# MONITORING YEAR 6 ANNUAL REPORT

# **OWL'S DEN MITIGATION SITE**

RE: Owl's Den Mitigation Site-Year 6 Monitoring Report

Wildlands Engineering, Inc. (Wildlands) has reviewed the Division of Mitigation Services (DMS) comments and observations from the Owl's Den Mitigation Site Draft Year 6 Monitoring Report received on December 20, 2021. The report text has been revised for the final submittal to reflect the most current condition of the site. Your comments and observations from the report are noted below in **Bold**. Wildlands' response to those comments are noted in *Italics*.

Figure 3.0 Integrated Current Condition Plan View (Key)
Owl's Den Mitigation Site
DMS Project No. 95808
Monitoring Year 6 - 2021

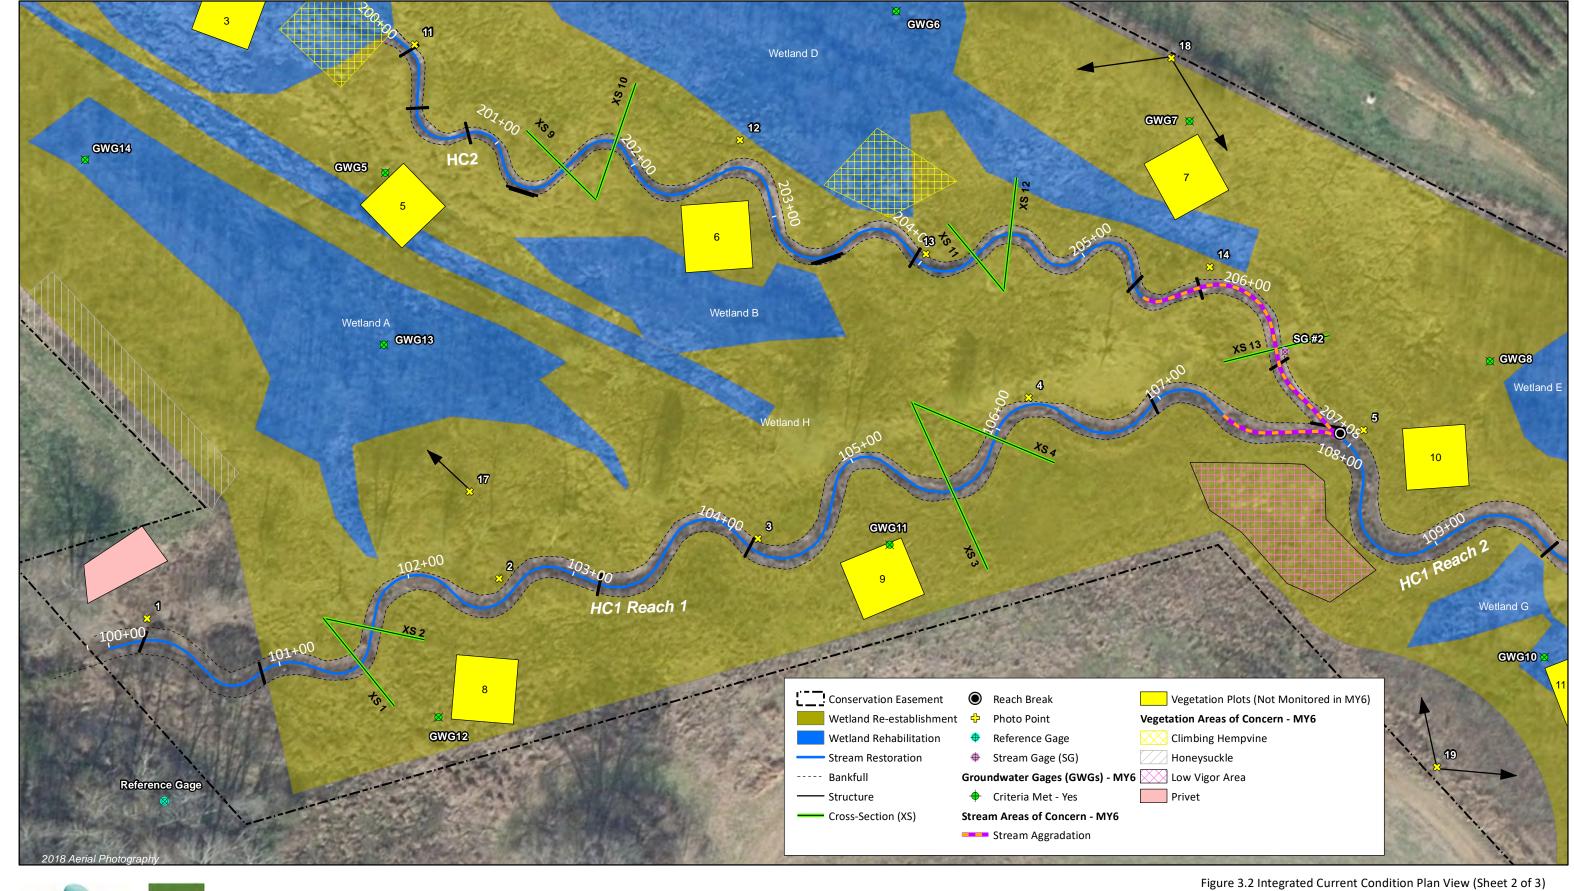
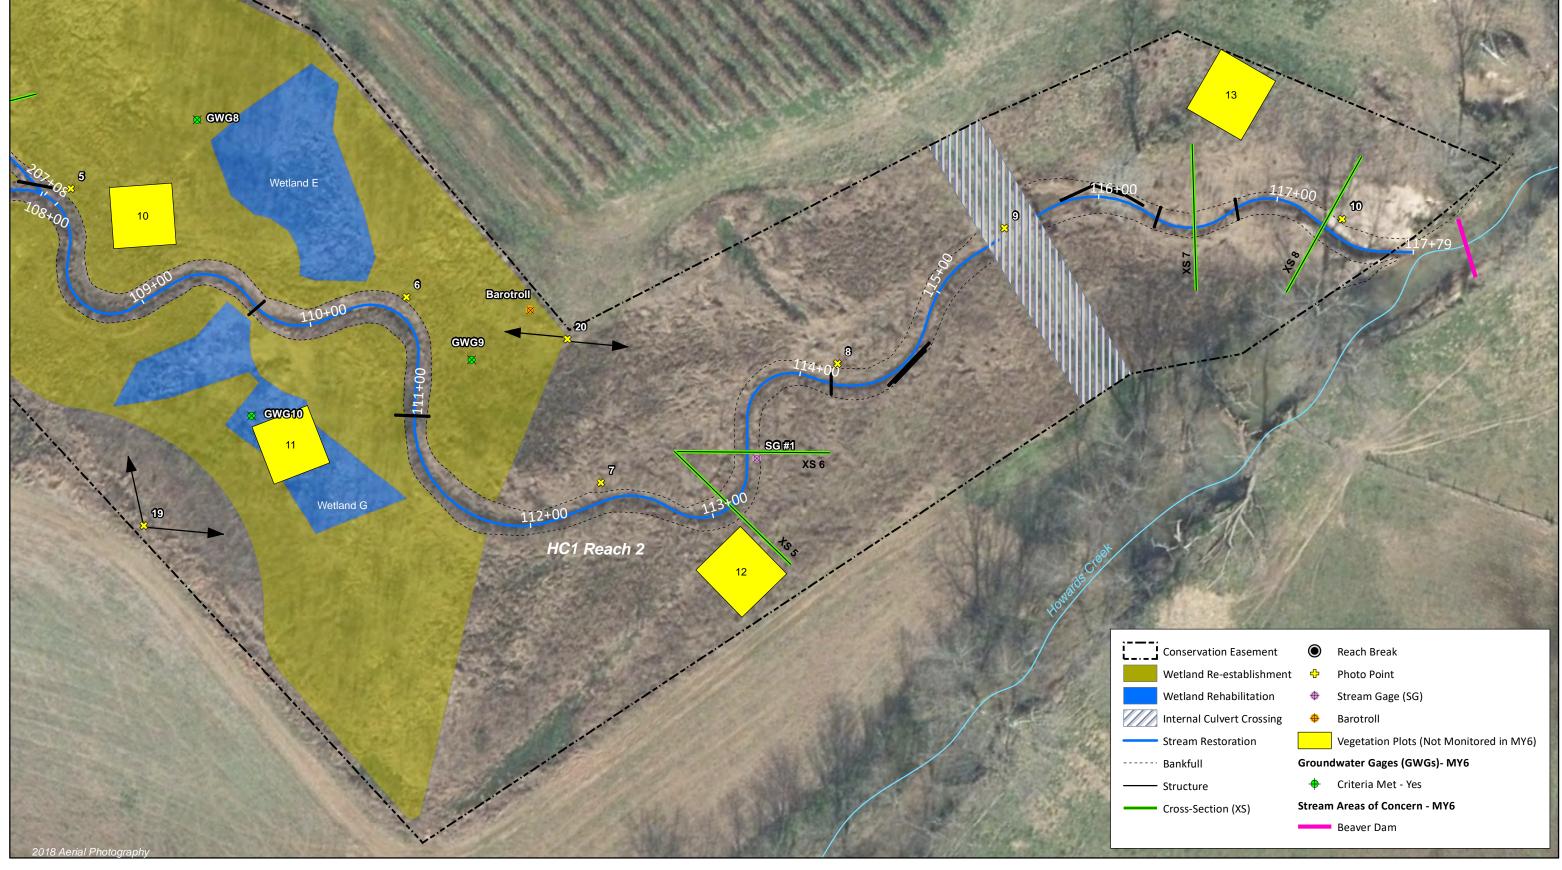
DMS' Comment: Section 1.2.2 Stream Areas of Concern and Management Activity: This section notes; "During a Site visit on October 18th, beavers were still active on the Site. Dams above and below the crossing had been re-established, and an additional dam was built on HC1 Reach 1 at station 101+00." Please update this section to indicate when these dams were removed and beaver trapped or provide a scheduled removal/ trapping date/s. DMS recommends removing beaver and beaver dams as soon as possible to avoid potential irregular monitoring data, project damage and additional project maintenance. As noted in the report text, beaver and beaver dams should be removed from the site through project closeout.

Wildlands' Response: The report and figures have been updated to reflect that all dams inside the project area were removed in early November of 2021 and not present during the final Site walk on November 10<sup>th</sup>, 2021. Wildlands is currently monitoring for continued beaver activity and will address re-established and/or newly established dams in MY7.
